Preliminary Plan 120160260, Springfield

Staff Report Date: 4/7/17

Description

PRELIMINARY PLAN OF SUBDIVISION
LOT 8, BLK 14A and OUTLOT A, BLK 19

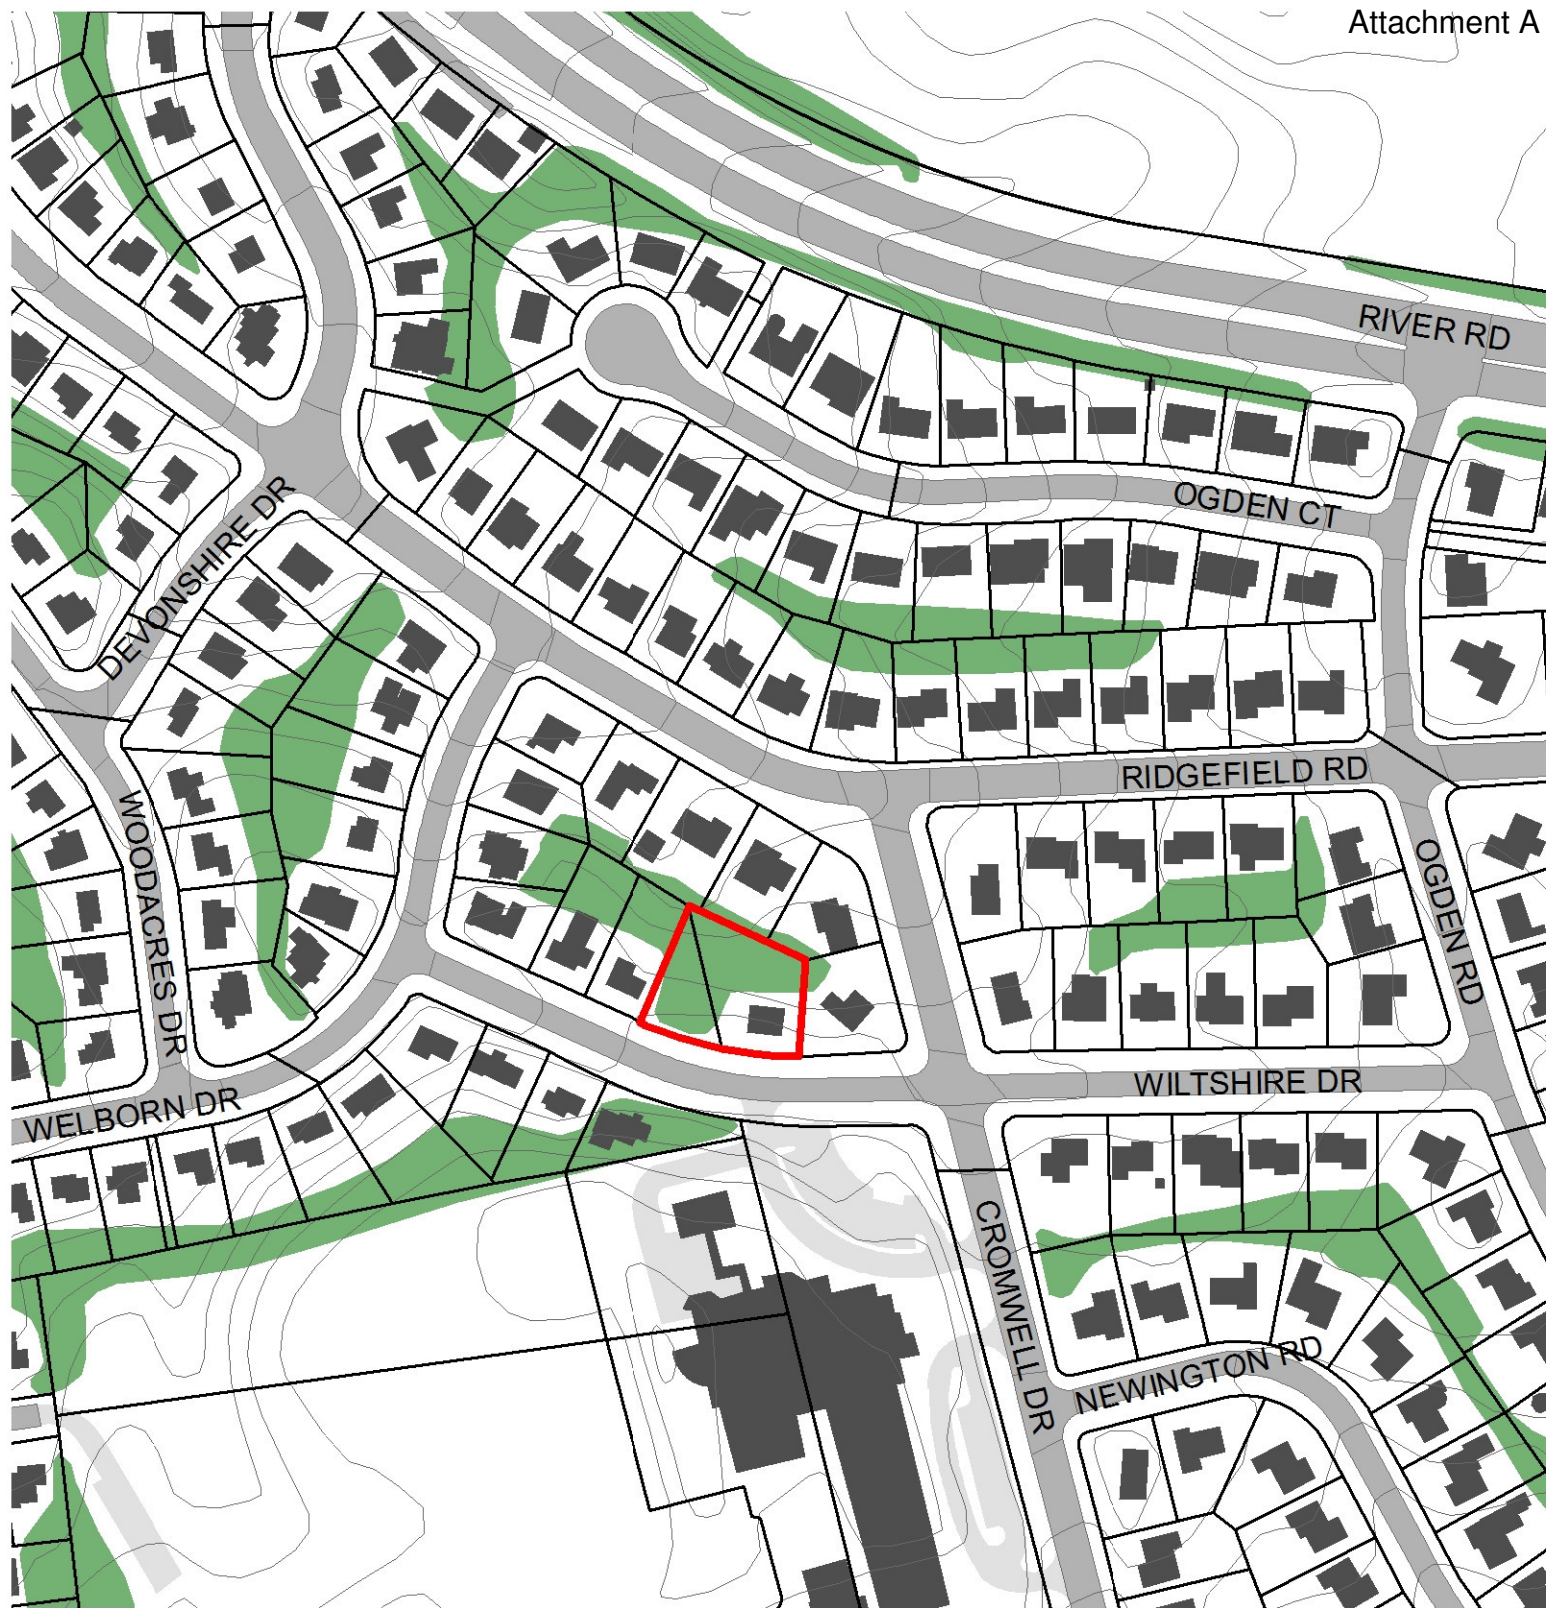
- 4) Prior to certification of the Preliminary Plan, the Applicant must submit, for review and approval by Staff, a revised Tree Save Plan that addresses the following:

- a. Revise the onsite tree planting list to include at least four, minimum 2.5-inch caliper, native canopy trees, and add a note stating the M-NCPPC Forest Conservation Inspector may allow substitutions of the onsite species.

- b. Revise the street tree species and locations as necessary to meet Montgomery County Department of Transportation ("MCDOT") requirements. The plans must retain two existing street trees and provide up to two additional canopy trees for a total of up to four street trees fronting the Subject Property. The street trees must also be included on the Preliminary Plan and approved by MCDOT staff prior to certification of the Preliminary Plan.

- c. Revise onsite planting locations to be at least five feet from any property line, measured to the center of the trunk.
 - d. Coordinate with Staff on necessary Tree Save Plan corrections, clarifications and note revisions.

- e. Show the required Category II Easement on the Tree Save Plan. The Category II Easement must be located at the north side of Lot 9 (behind the existing house), measuring approximately 2,000 square feet, as shown in the Staff Report.

- f. Provide a note stating that the Applicant must make good faith efforts to secure permission from adjacent property owners for mitigation of impacts to off-site trees.

- 5) Prior to certification of the Preliminary Plan, revise the preliminary plan to show the required Category II Easement.
- 6) Prior to removal of any tree protection fencing or sediment control fencing, the Applicant must plant four native canopy trees on Lot 10, as shown on the approved Tree Save Plan.

Looking Right from
Proposed Entrance.

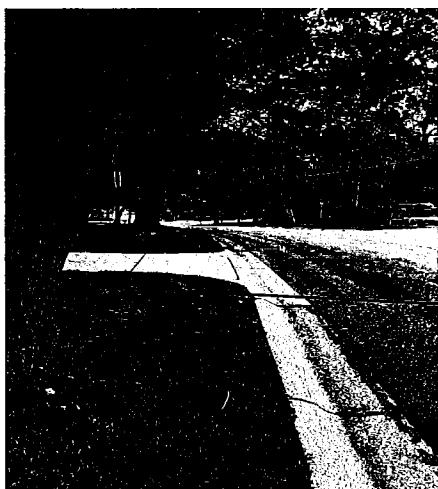
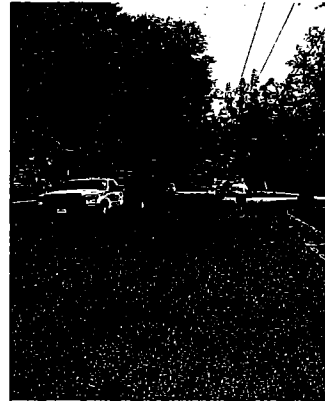
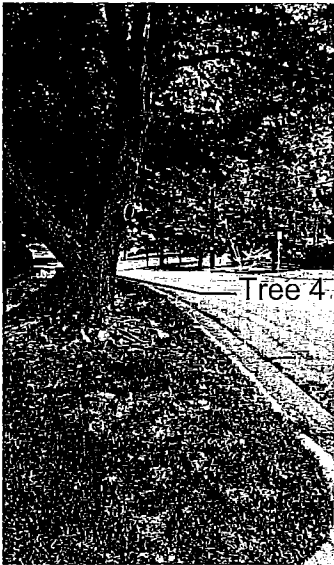
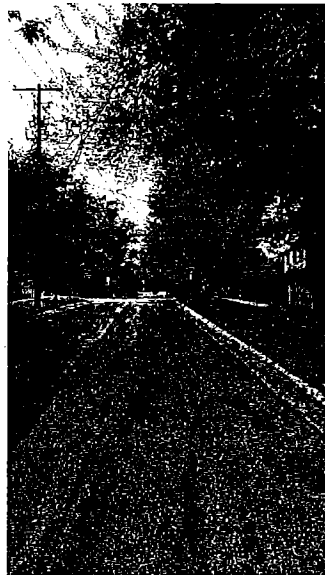
Replacement Trees 1 and 2 to be Planted Behind Sight Distance Sight Line

—Tree 1 To Be Replaced

—Tree 2 To Be Replaced

Replacement Trees 1 and 2
to be Planted Behind Sight
Distance Sight Line

—Tree 3 To Be Removed

Tree 3 To Be Removed

Tree 4 To Be Remain

1. All comments from the previous DOT letter dated January 9, 2017 apply unless conditioned in this letter.
2. The revised sight distance study has been accepted. A copy of the revised Sight Distance Evaluation certification form is enclosed for your information and reference.
